Presentation from Northwatch

Darlington New Nuclear Project

Application to renew the nuclear power reactor site preparation licence for the Darlington New Nuclear Project

Commission Public Hearing

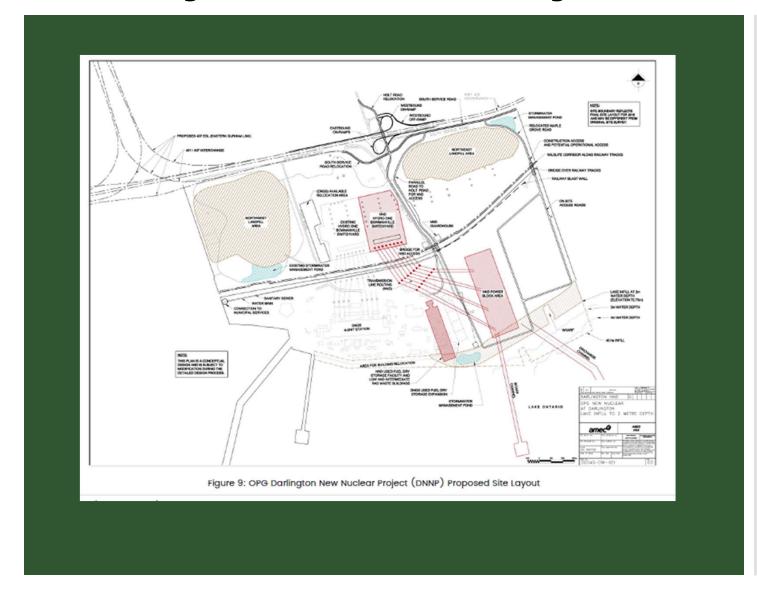
REQUEST: The Commission require OPG to provide a complete project description following selection of their preferred reactor design prior to re-filing their application to renew the site preparation licence, to provide the Commission with an information base to consider whether the previous EA was for the same project as which OPG is not proposing to undertake.
